Proposed CAO for PG&E's Chromium in Hinkley Groundwater

November 4, 2015

**Douglas F. Smith, PG
Supervising Engineering Geologist
Water Board Advisory Team**

e. Plume mapping requirements

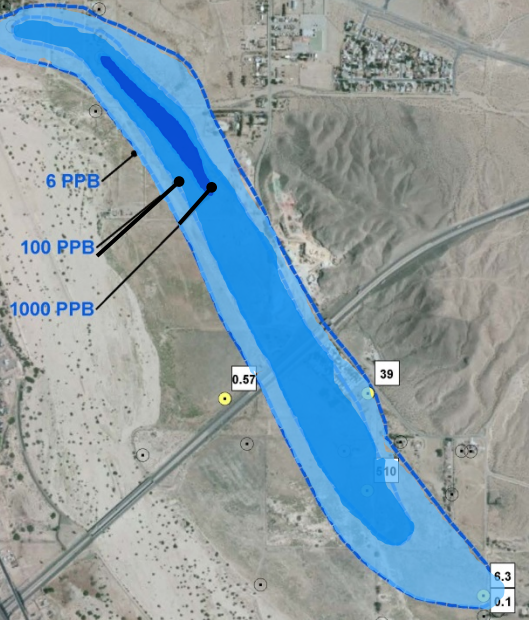
- Should connect monitoring wells $\frac{1}{2}$ mile apart
- Continue mapping for consistency and comparability to previous maps
- Will reopen disagreements with PG&E about mapping requirements
- Gives perception of the plume disappearing in certain areas

- Isoconcentration contour lines will be substantially similar to maps previously required and shows effects of remediation
- Must incorporate all science in drawing the isoconcentration lines, including the USGS results
- Added a dispute resolution process
